Re: HA61.321776: BusConnects Galway: Dublin Road Development, Galway

Description: The scheme is 3.9km long starting from Wellpark in the west to the junction of Doughiska Road in the east and involves the provision of bus lanes and cycling facilities and junction rearrangements.

Location: Renmore Park

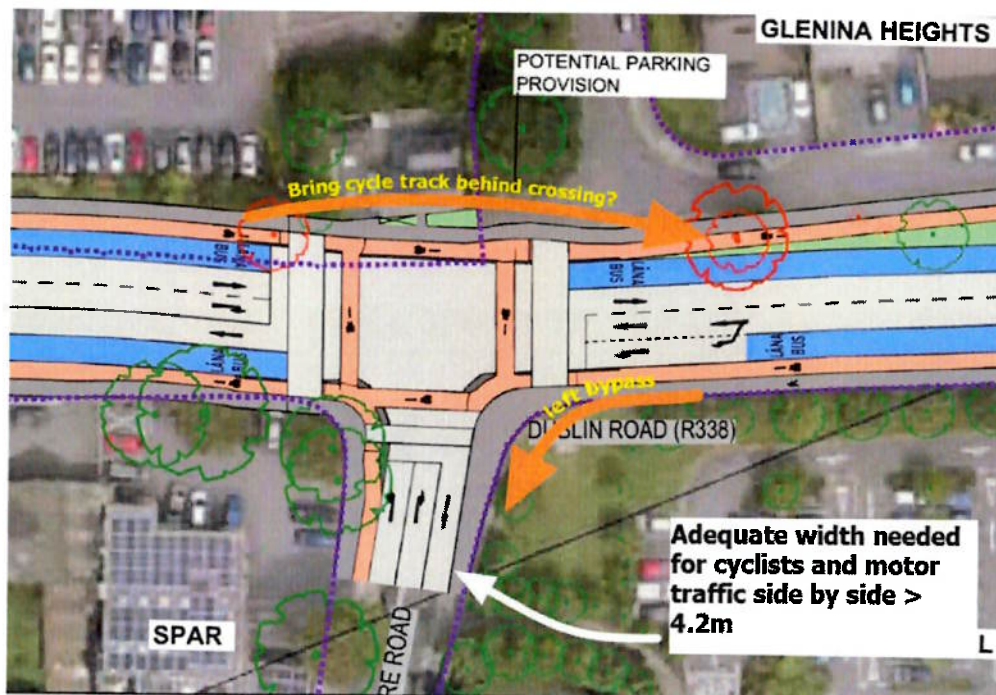
Observation: A continuous footway/cycle track treatment is needed across the mouth of the junction.

Figure: Screenshot from Google street view showing the current access arrangements at the ATU campus beside the Belmont Housing development.

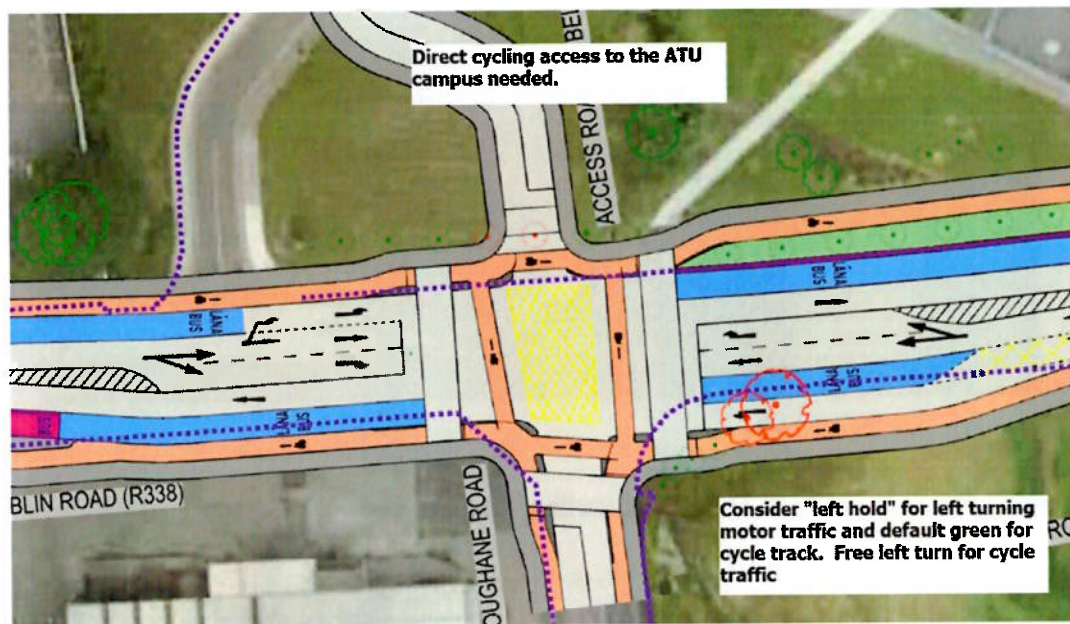
Consideration should be given to making the Belmont junction into a cyclops layout with a direct link into the ATU campus. On the westbound arm consideration should be given to a hold-the-left arrangement on the R338 with a default green for westbound cycle traffic. This would also help to reduce the use of the roads within Renmore as a rat run for drivers trying to avoid queues on the Dublin Road. Consideration should be given to making the eastbound arm flashing amber for motor traffic turning into Belmont.

Location: Skerritt Roundabout

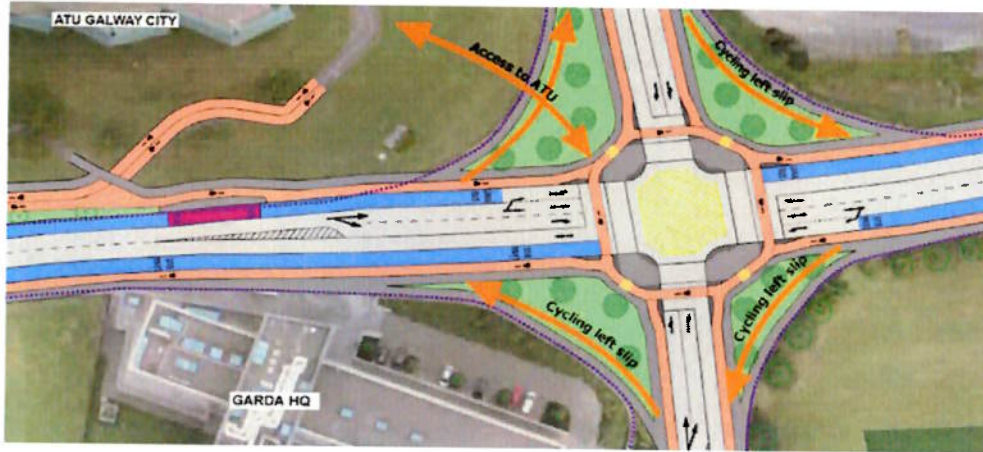
The proposed cyclops junction at the current Skerritt Roundabout is welcome.

- Left slip lanes are needed for cyclists on all quadrants. Reason: Otherwise a proportion of cyclists will use the footpaths to take the shortest path. There is already a precedent for left slips for cycling at other locations in Galway.
- A new access is needed into the ATU campus: Reason: If there is no access here then a likely outcome is that cyclists coming from the south will cross at the Skerritt and cycle in the wrong direction along the cycle track north of the road.
- Observation: Possible potential for a diagonal crossing running northwest/southeast to new access with all green for foot and cycle traffic.

Location: Merlin Park Entrance

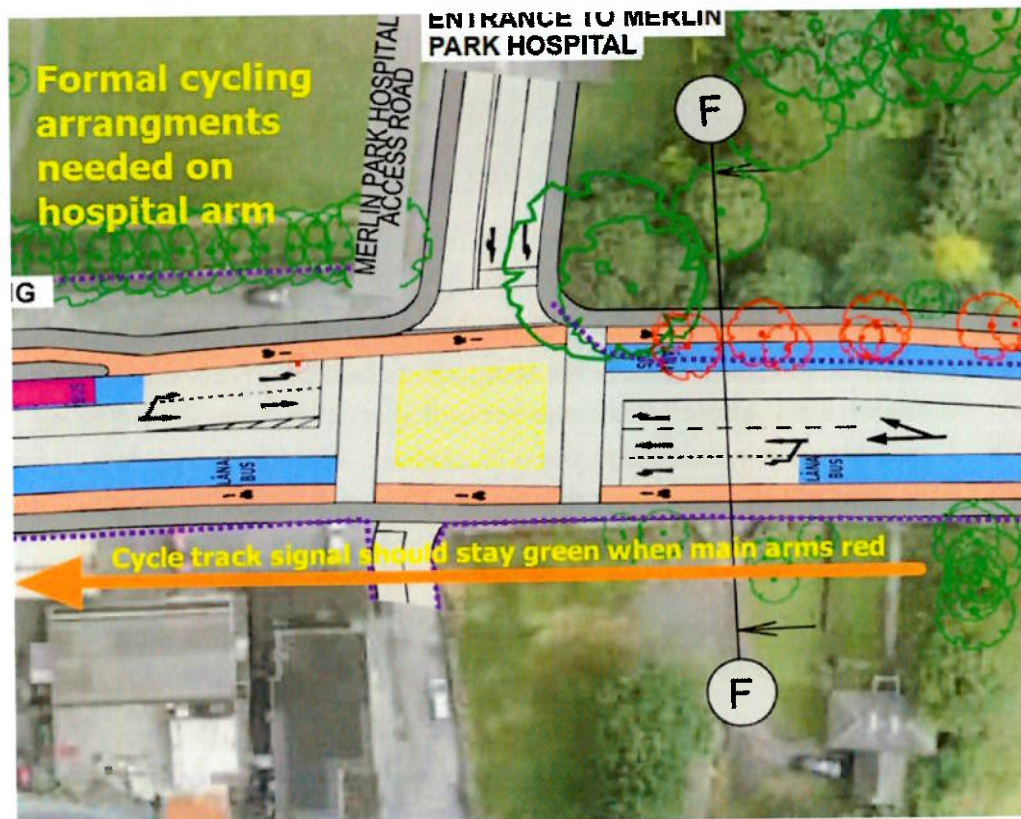
The signalisation of the Merlin Park entrance is very welcome and is something local community members have sought for years. The hospital campus is a potential source and destination for cycle traffic and potentially the main route towards the city from Doughiska/Castle Park. Consideration should be given to formal cycling arrangements into and out of the campus. Cyclists should have a junction left-bypass into the campus and some means to get past queueing motor vehicles to turn right for the city. On the south side of the junction the signals for the cycle track on the transverse arm should remain green or flashing amber for cycle traffic unless the pedestrian crossings are in use.

Figure: Extract from the drawings for the non-statutory consultation showing the cycle track passing behind the footpath at the Galway Crystal/Merlin Lane junction.

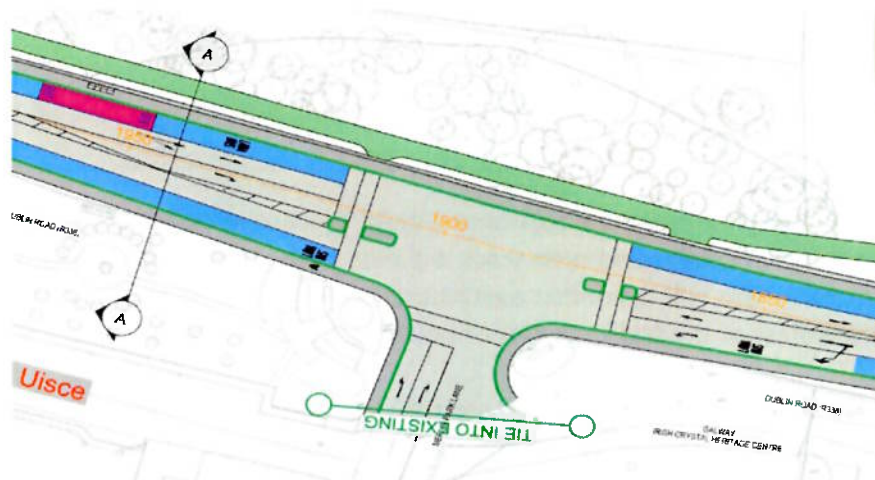
Observation: The floating bus stop/island should be continued to, and through, the traffic lights. So the outbound cycle track will pass to the left of the pedestrian space at the junction. This will deconflict eastbound cycle traffic who will be able to keep moving regardless of the traffic signals or pedestrian crossing state.

In the drawings for the non-statutory consultation there was a proposal for a two-way cycle track only on one side of the road and behind the footway at this point. The current arrangement with cycle tracks on both sides is better overall but the previous arrangement behind the footway has advantages. The developer clearly already has drawings for this.

Location: Junction of R338 Dublin Road and Coast Road

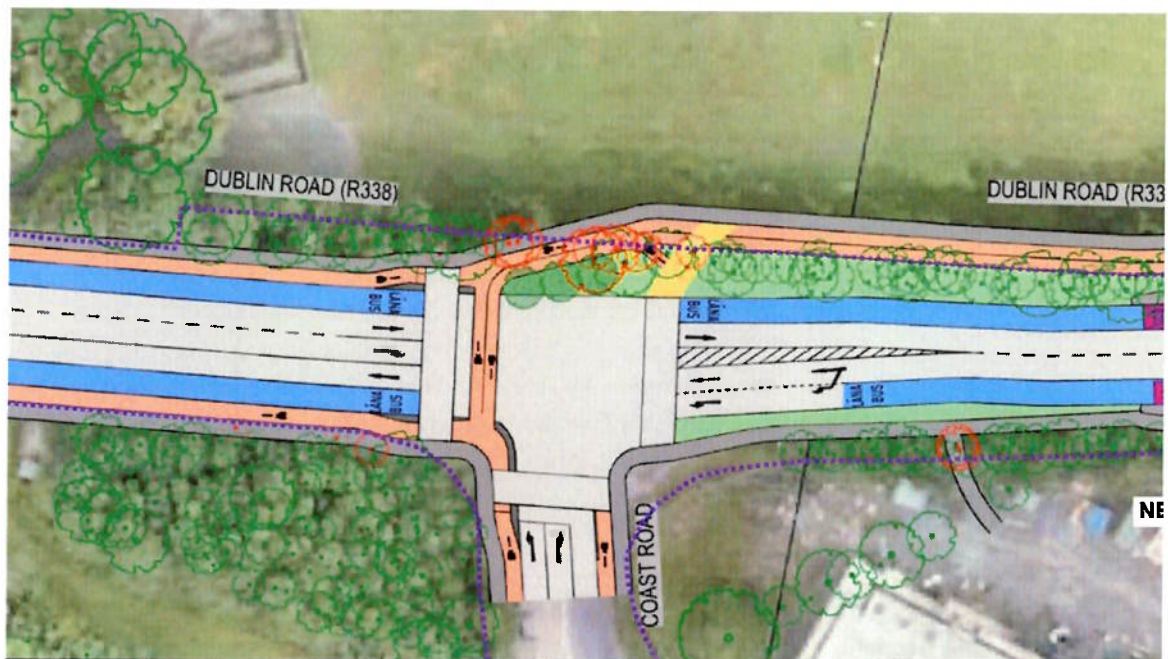
Observation: Cycling bypasses for cyclists turning left should be available on all arms. (Land does not seem to be an issue here).

Observation: The design of the junction is not intuitive and it is not clear how cyclists are supposed to access the coast road to travel towards Oranmore.

Consider converting this junction to a Cyclops junction.

Location: Castlegar GAA Pitch

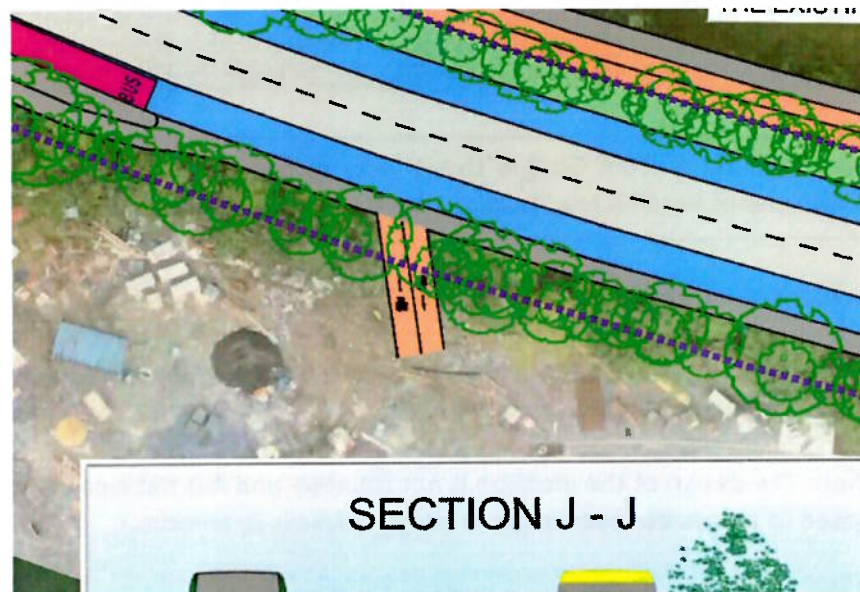
Observation: In the plans formal cycle facilities are only shown on the north side of the road. In the plan the footway on the south side of the road is marked as “Shared Pedestrian Cycle path”. The cross section shows this feature as being 1.8m.

The south side of the road is the natural route towards ATU and the city for cycle traffic coming from a large residential area south of the Dublin Road at Roscam. The planning drawing also shows a cycle track joining this “Shared Pedestrian Cycle path” from the south.

The 2011 National Cycle Manual (NCM) states that shared facilities next to traffic should have a combined width of 3m.

- Shared facilities next to vehicular traffic should have a minimum combined width 3.0m
